1  +-----+
2  |                8802-3/802.3 REVISION REQUEST                |
3  +-----+
4  DATE: 21 May 2017
5  NAME: Andrew Gardner
6  COMPANY/AFFILIATION: Analog Devices (formerly Linear Technology)
7  E-MAIL: agardner@linear.com
8
9  REQUESTED REVISION:
10     STANDARD: 802.3bu
11     CLAUSE NUMBER: 104.4.4.1
12     CLAUSE TITLE: Detection probe requirements
13     PROPOSED REVISION TEXT:
14
15     Change the max limit for item 5 in Table 104-3 PSE PI detection state
16     electrical output requirements from 200nF to 2.64uF. 2.2uF+20% =
17     2.64uF.
18
19     RATIONALE FOR REVISION:
20
21     The 200nF maximum limit on a PSE's Cout is limiting. The current maximum
22     limit in some common circuit configurations can cause stability issues.
23     The attached analysis demonstrates that the proposed change does not
24     create the potential for one PSE to detect another PSE as a valid PD.
25     In addition, since no other detection parameters are affected, there is

# 1 Analysis of Proposed Change to $C_{out}$

## 2 Maximum Limit in Table 104-3

*Figure 1 – Circuit Model of PSE Detection of another PSE*

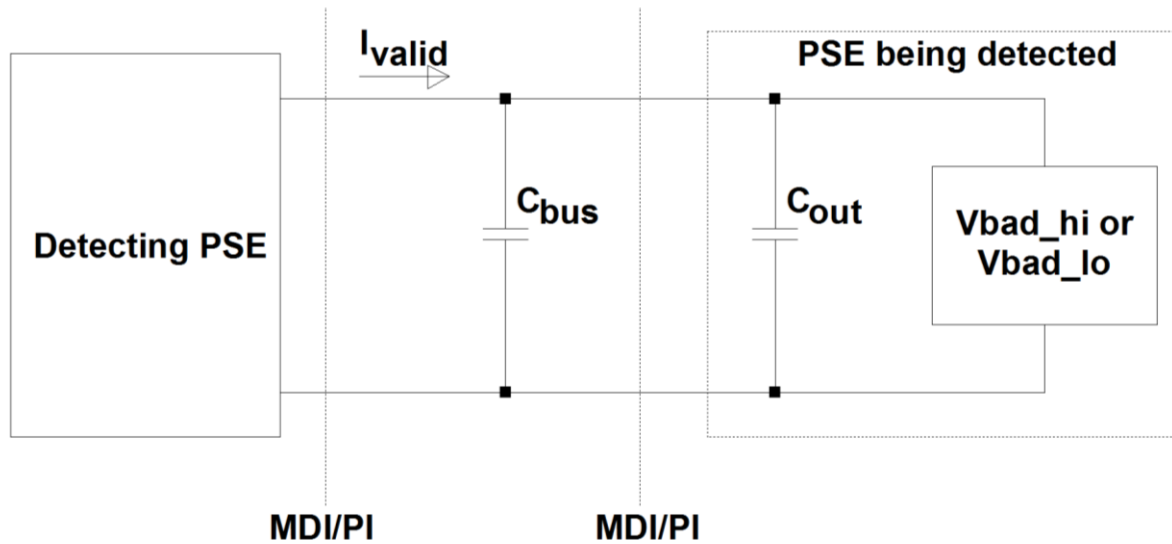
5 Figure 1 illustrates a circuit model of a PSE attempting to detect another PSE. Ranges for values of  
6  $I_{valid}$  and  $C_{out}$  are given in Table 104-3.  $C_{bus}$  is constrained to be less than 6nF by Item 19 in Table  
7 104-8 (SCCP electrical requirements).

8 In order to guarantee that a PSE cannot detect another PSE as a valid PD, the total amount of  
9 capacitance seen by the detecting PSE ( $C_{bus}+C_{out}$ ) must be low enough so as to ensure that the  
10 voltage at the MDI/PI of the detecting PSE does not remain in the window  $V_{bad\_lo\_PSE}$  max to  
11  $V_{bad\_hi\_PSE}$  min for more than  $T_{sig\_hold}$  min. The expression for the amount of time spent in the  
12 window,  $t_{bad\_lo\_hi}$ , is given by Equation 1.

13 
$$t_{bad\_lo\_hi} = (V_{bad\_hi\_PSE} - V_{bad\_lo\_PSE}) \times (C_{bus} + C_{out}) / I_{valid} \text{ (Equation 1)}$$

14 The maximum value of  $t_{bad\_lo\_hi}$  occurs when  $V_{bad\_hi\_PSE} = 5.45V$ ,  $V_{bad\_lo\_PSE} = 3.7V$ ,  $I_{valid} = 9mA$ ,  $C_{bus} = 6nF$ ,  
15 and  $C_{out}$  is at the maximum allowed value. Substituting 2.64 $\mu$ F for  $C_{out}$  yields  $t_{bad\_lo\_hi} = 515\mu s$  which  
16 is substantially less than the  $T_{sig\_hold}$  min value of 1ms.

18 Increasing the maximum limit for  $C_{out}$  from 200nF to 2.64 $\mu$ F in Table 104-3 allows PSEs to be  
19 implemented at lower cost and complexity without creating the potential for one PSE to detect  
20 another PSE as a valid PD.
